67.1

Subject: Throttle Lever Spring

Affected engine

L 2400 EF, DF, L 2400 ET, DT

Fig. 2

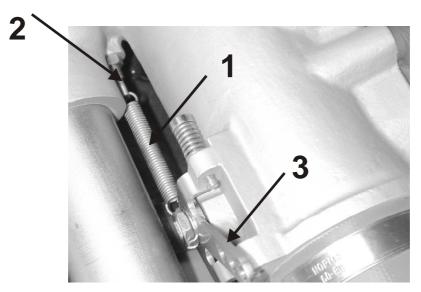
On engines that were not yet modified according to TB 67 (Fig. 2) the old spring (1) must be removed also.

• After removing the spring (1) the spring hanger (2) can remain at the engine.

Fig. 1

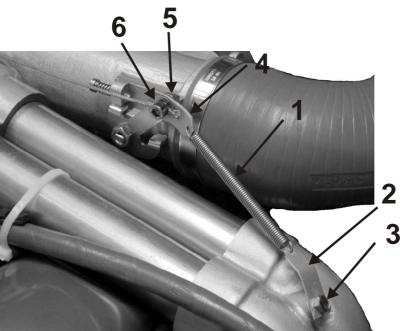
**information:** Broken throttle lever spring in several cases. In the worst case the throttle lever can get stuck with the

Compliance: The assembly kit used according to TB 67 (Fig.1) must be removed and replaced by an assembly kit ac-

cording to Fig. 3
